PUBLIC UTILITIES COMMISSION

SUBJECT: Substation Audit of PG&E's Oakport Headquarters (HQ)

**CPUC AUDIT FINDINGS OF PG&E OAKPORT
SUBSTATION HEADQUARTERS
March 13 - 17, 2023**

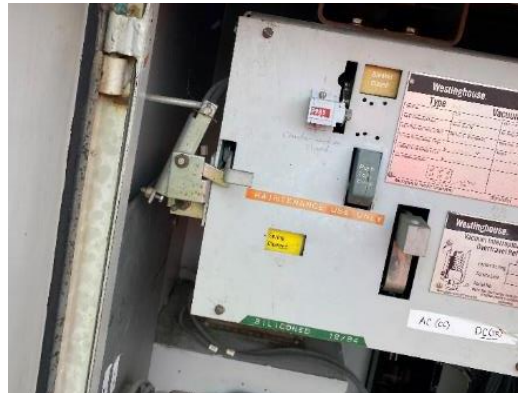
4.1. The position indicator is faded on CB 1101/2. PG&E has a preexisting LC notification (#125552589) to correct this issue.

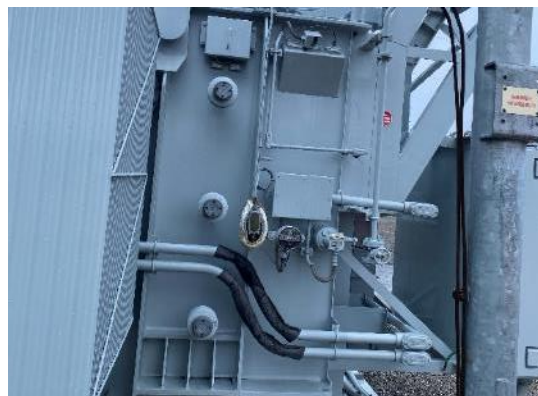
5.1. The counter is illegible at CB 1106/2.

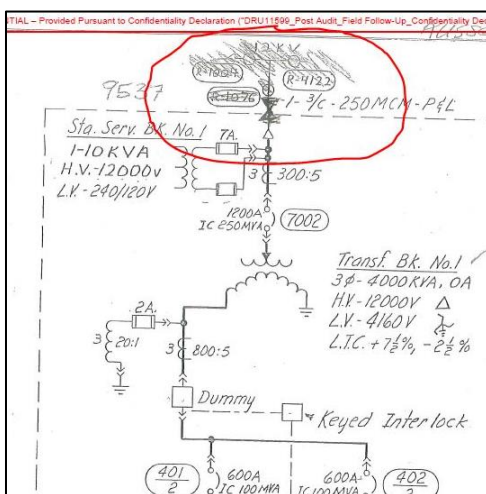
The cabinet heater at Switch 7334 is not working. PG&E has a preexisting LC notification (#123086791) to correct this issue.
